IEEE P802.3bt PSE State Diagram Update

Dan Dove, DNS for LTC

March 4, 2015

33.2.4.7 State diagrams

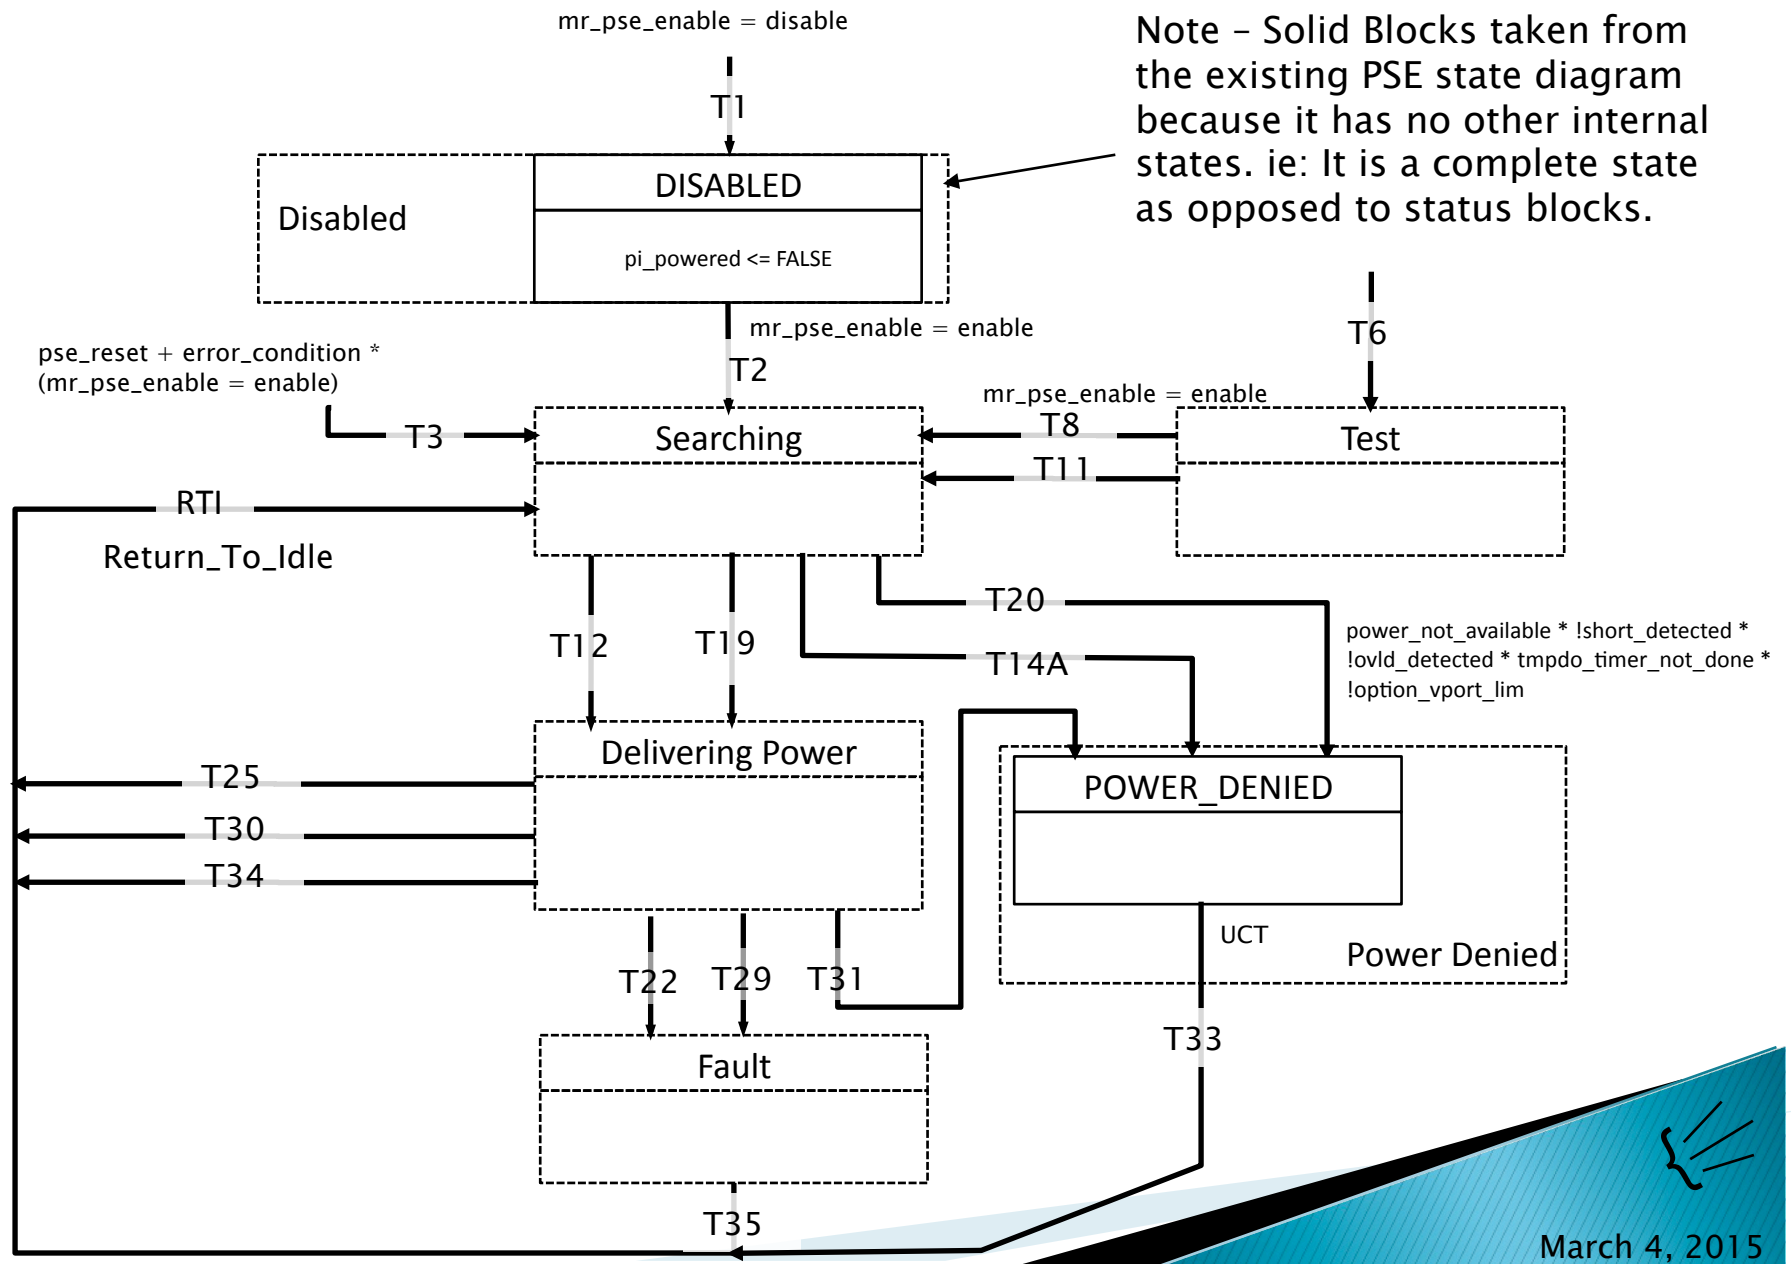
- The classification portion of the existing PSE State Diagram is assumed to be the current page pretty much as is.
- A few minor modifications have been made that are assumed to be errors.

- A typo taken out of T23 (removed hyphen)
 - A1 arc added to “Searching” block since it appears as entry into the Classification State
- It’s the author’s opinion, that a good specification is done from the top down, rather than the bottom up. The existing PSE state diagram, while it accurately represents behavior of a PSE, appears to have been designed from the bottom up to explain PSE behavior, rather than to direct design.

High Level State Diagram

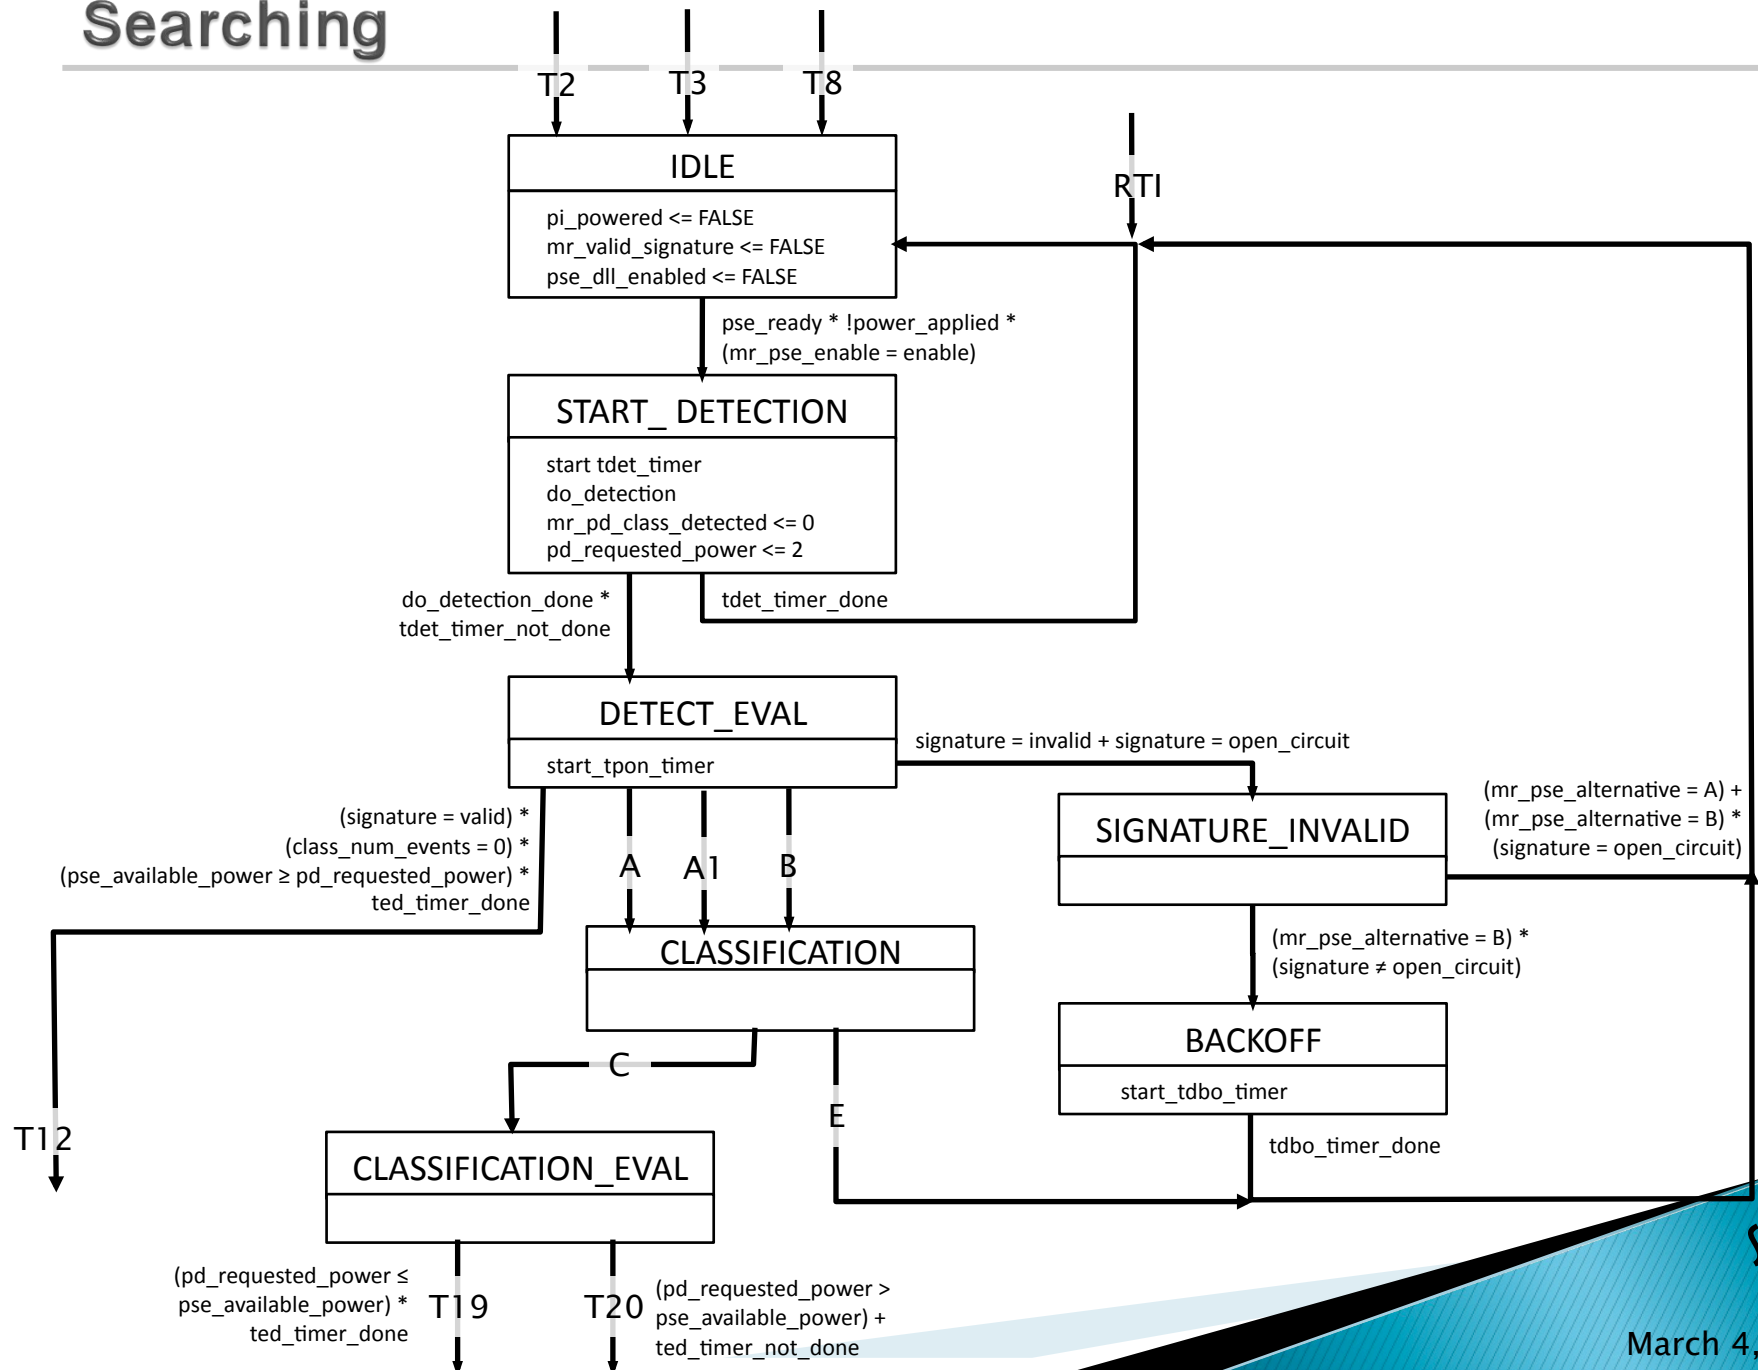
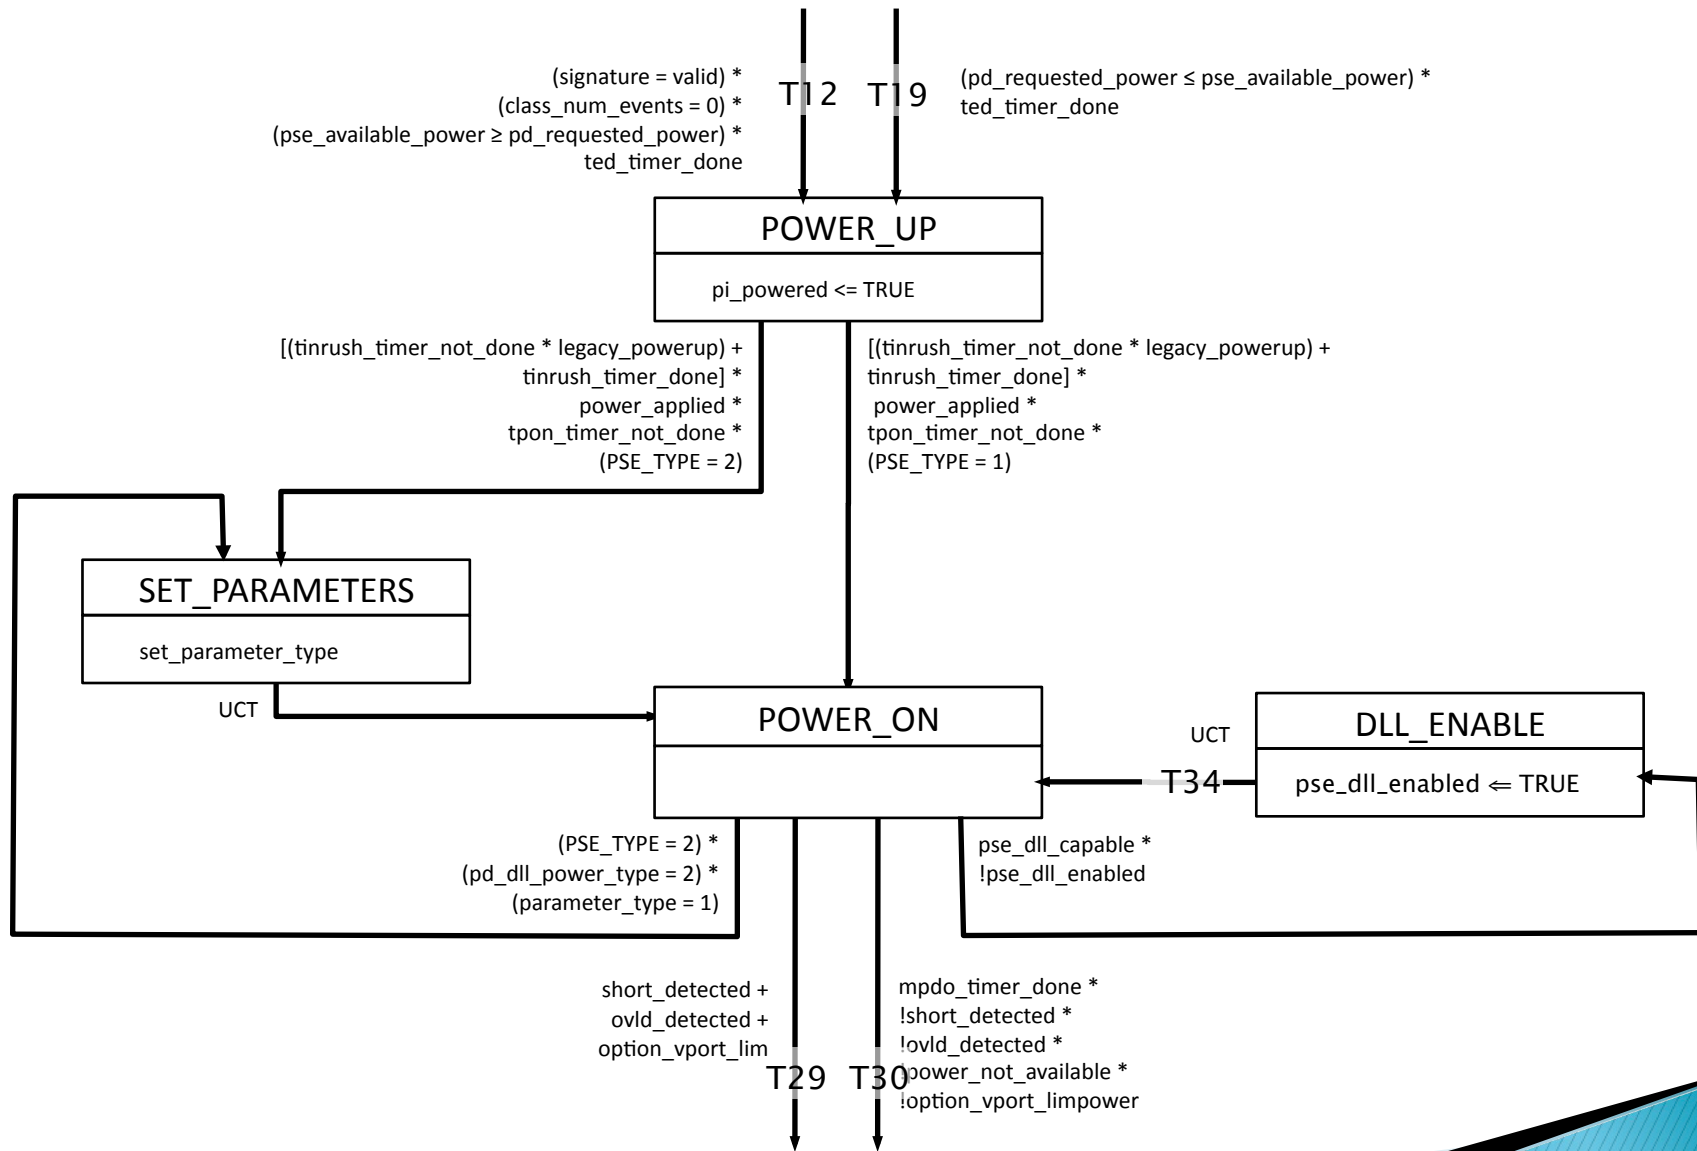
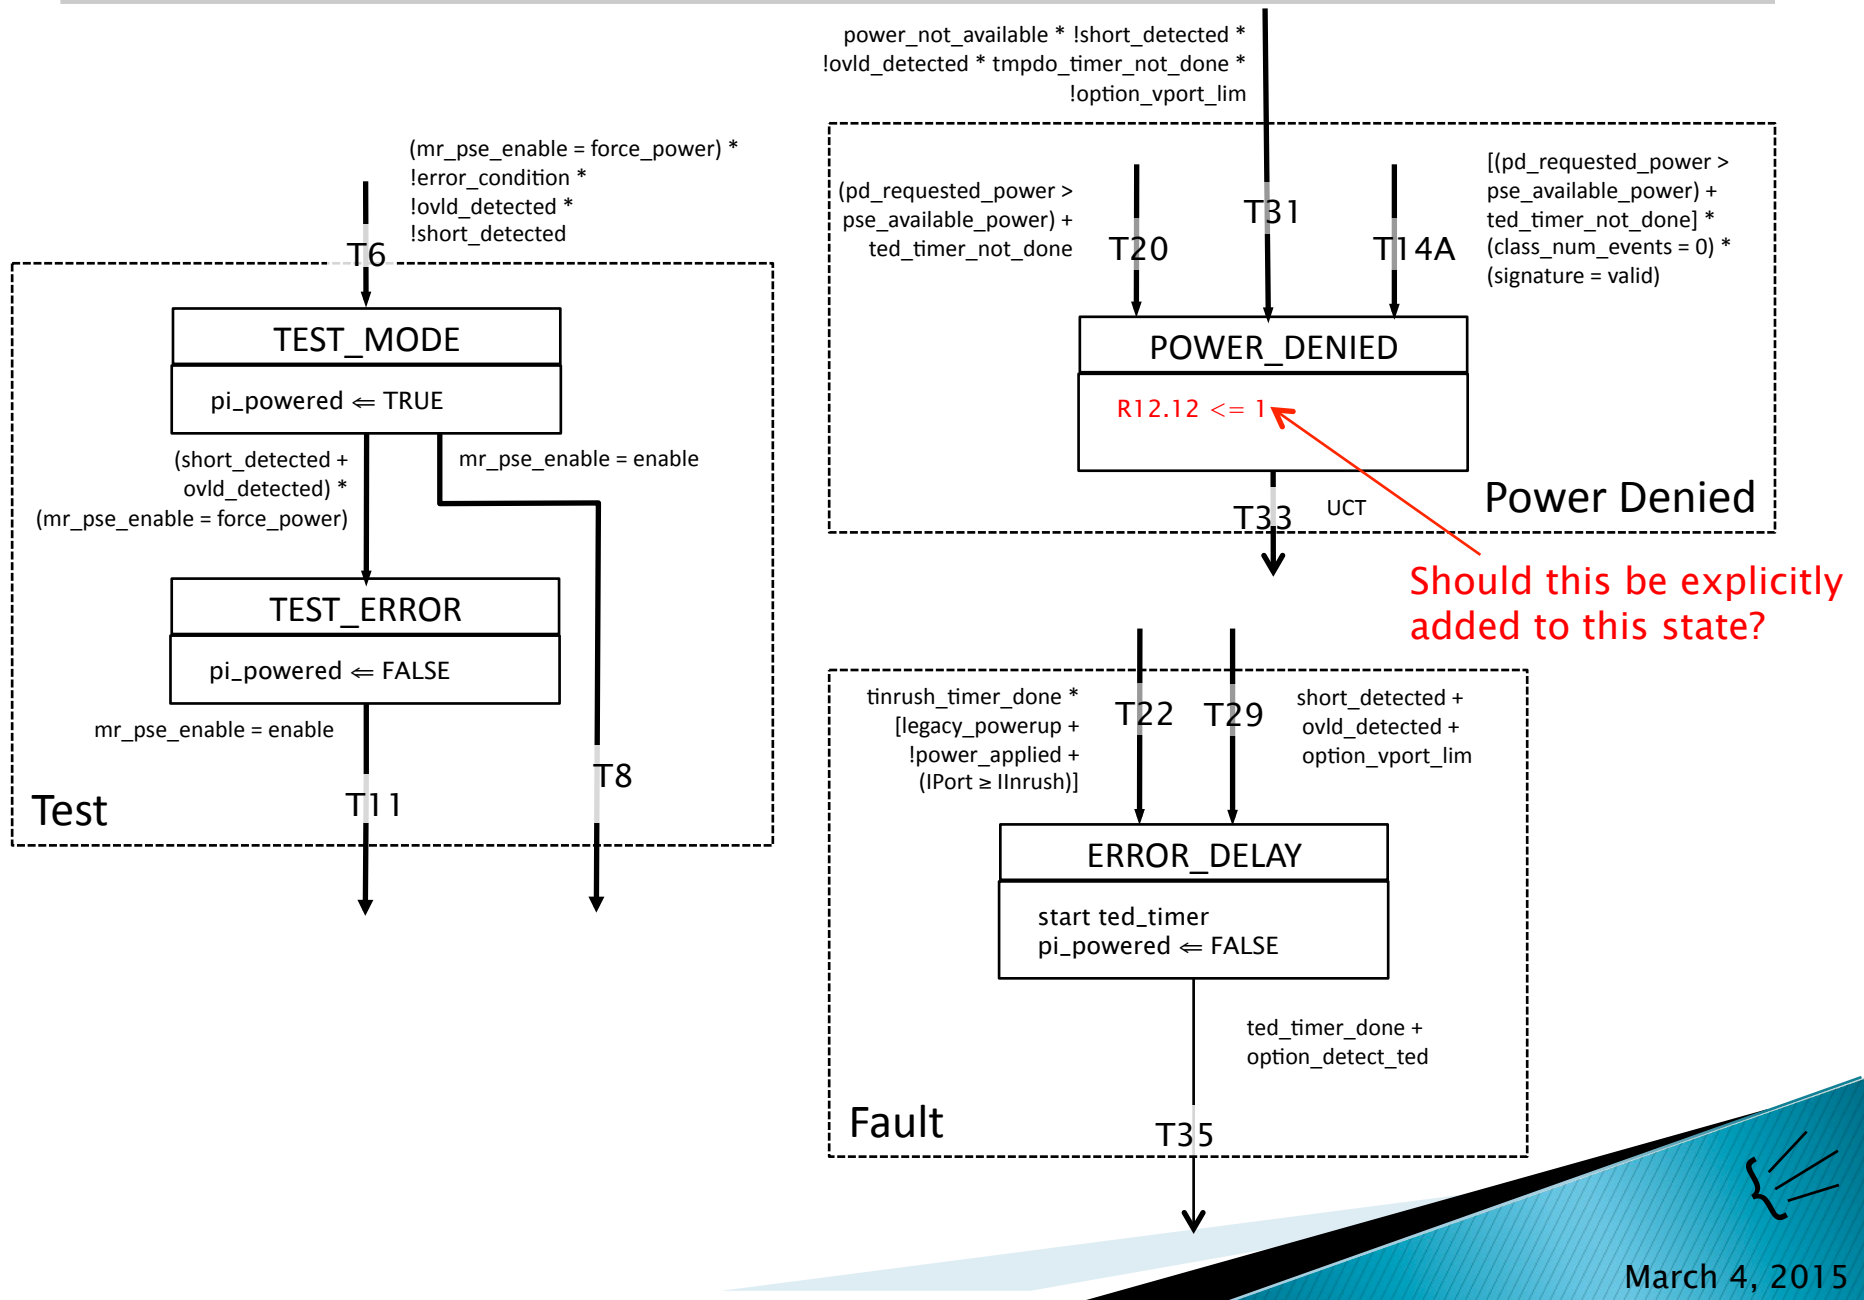
- First, we create a high-level state diagram with blocks defined by the management status register.
- Next, we identify all arcs in the existing PSE state diagram with numbers.
- Next, we build a top-level block diagram showing all of the relevant arcs between those blocks
- Then we redraw the individual blocks with arcs coming in, exiting.
